## Product Notice: New WarmWire Strap

### Product Details

The new WarmWire Strap has improved. Some of the new features include:

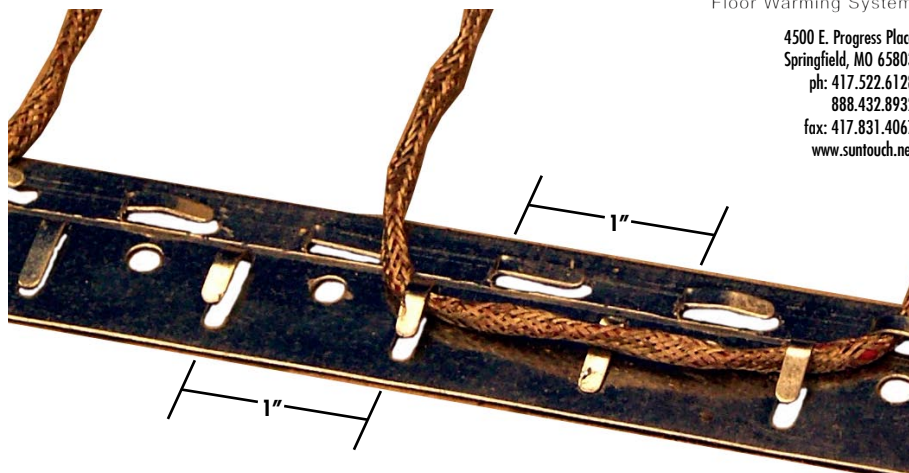
- **Two rows of tabs:** each row is off-set at right angles from each other allowing for easier installation for the various wire spacings.
- **Longer, narrower tabs:** more flexible tabs better accommodate larger wire sizes.
- **Wider strap:** increased from 3/4" wide to 1-1/8" wide provides a flatter installation.
- **New installation methods:** use the standard screw as with the older strap or use 3M's type 90 spray adhesive for secure attachment to hard surfaces such as concrete.
